Product Change Notification

Change Notification #: 116123-01
Change Title: Intel® Server Chassis R1304WFXXX and R2000WFXXX, Intel® Server Systems R1304WFTYS, R1304WF0YS, R1208WFTYS, R2308WFTZS, R2208WF0ZS, R2208WFTZS, R2208WFQZS, R2312WF0NP, R2312WFTZS, R2312WFQZS, R2224WFQZS, R2224WFTZS, PCN 116123-01, Product Design, Order Code Rear panel and rear brackets new design
Reason for Revision: Update new MM order code for R1304WFXXX SKU

Date of Publication: December 01, 2021

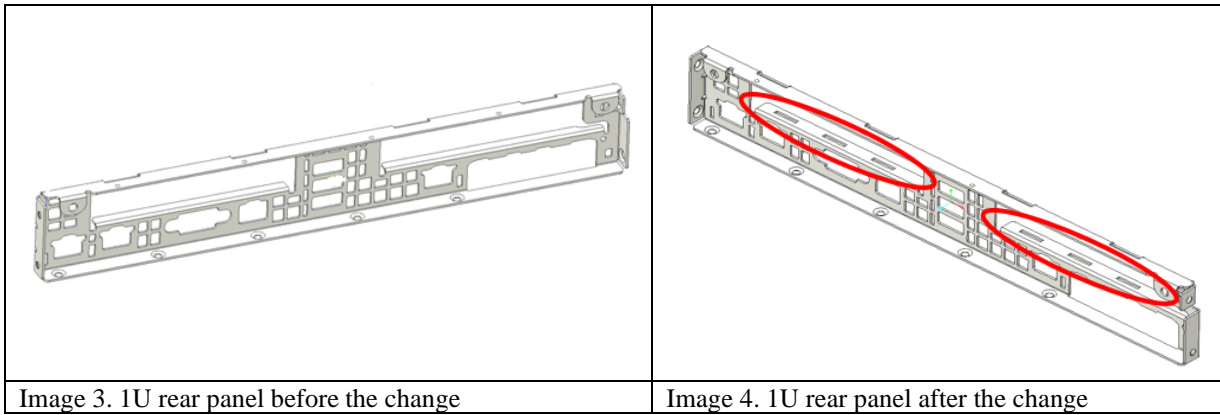
1. Change the design of the left rear bracket

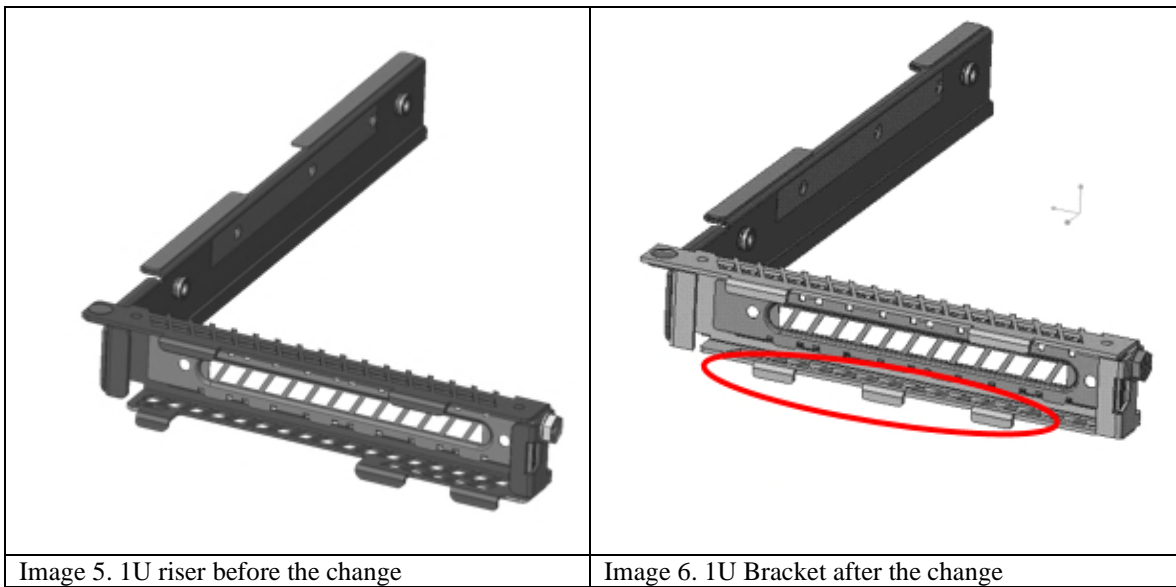
2. Adding holes to the rear panel

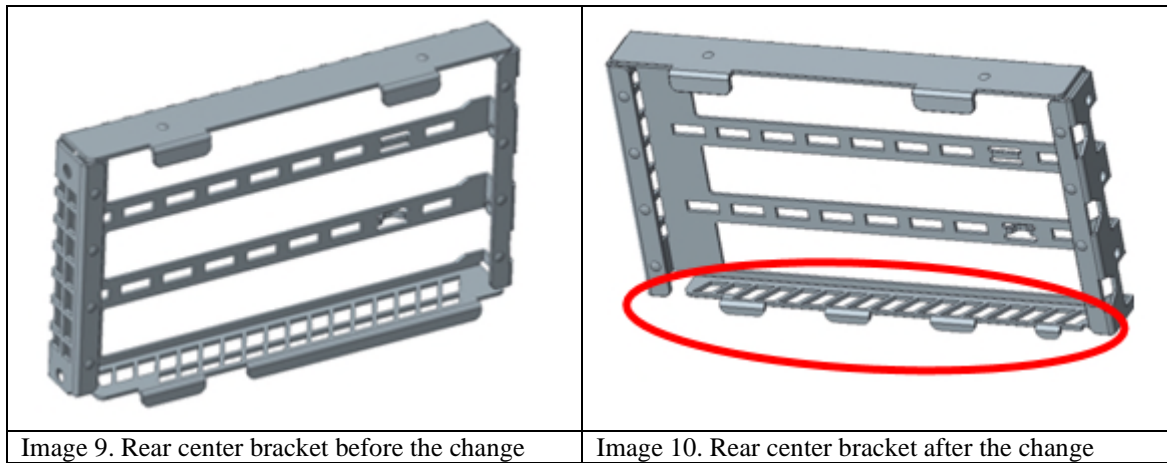
1. Adding holes to the rear panel.

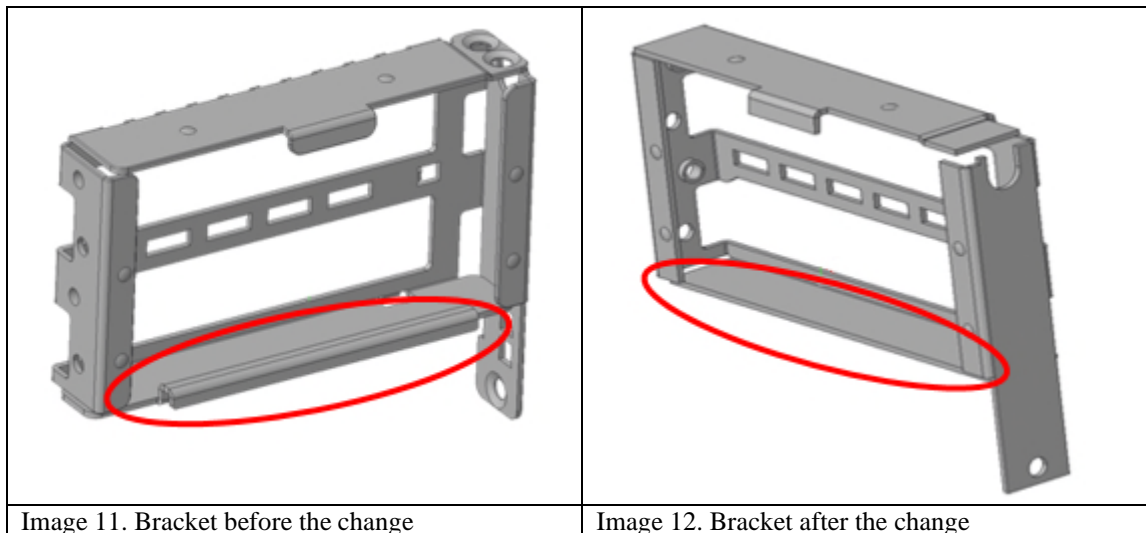
2. The center rear bracket has a new design

Image 13. 2U right riser bracket before the change

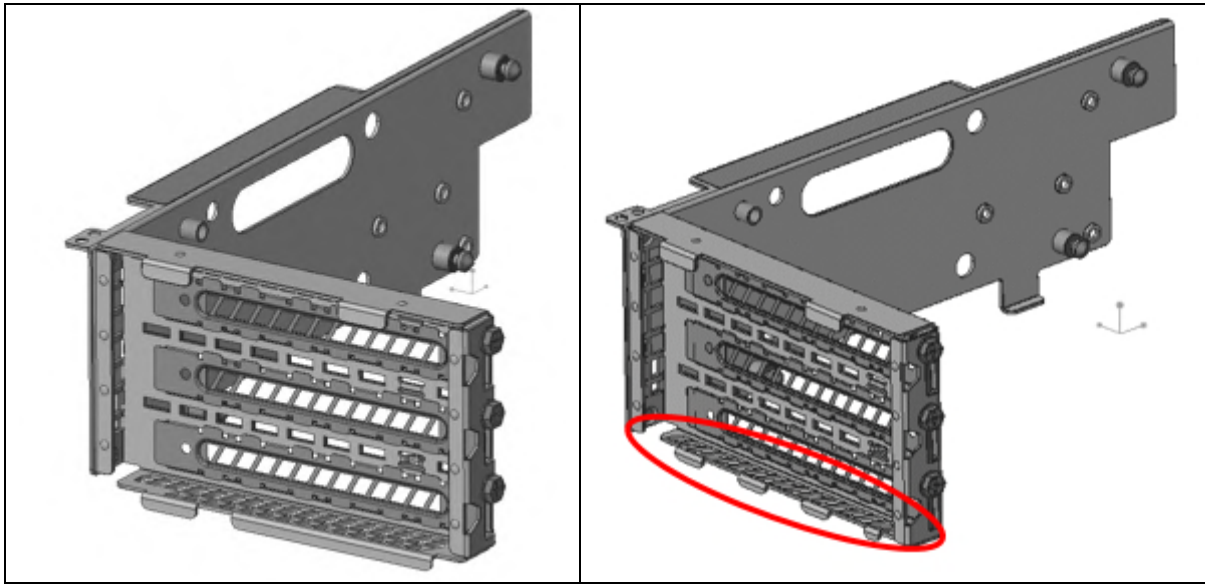
4. The right riser bracket has a new design.

Image 15. 2U left-center riser bracket before the change

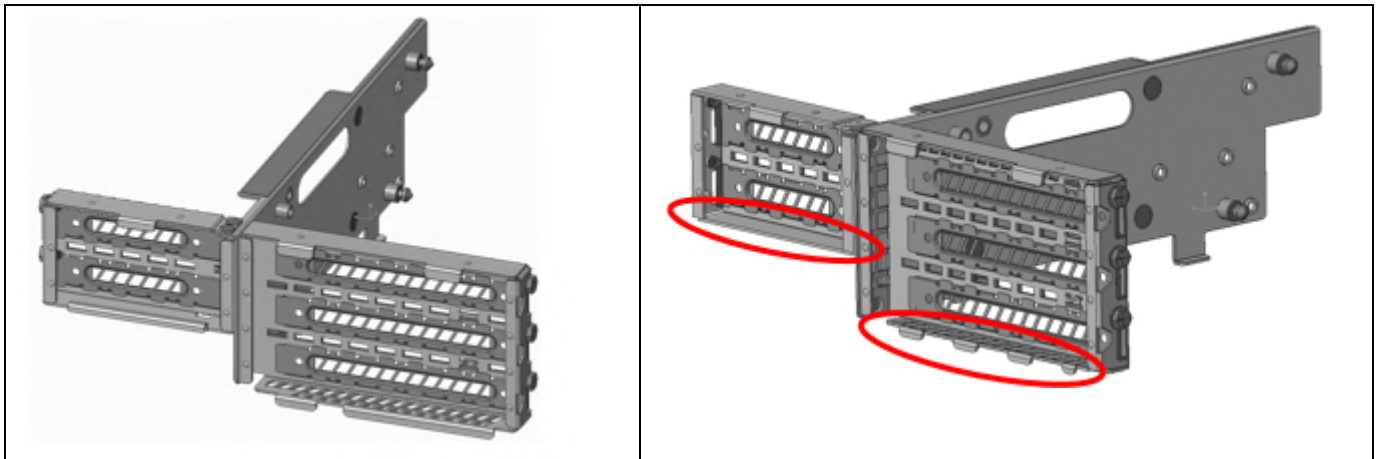
5. The left-center riser bracket has a new design.
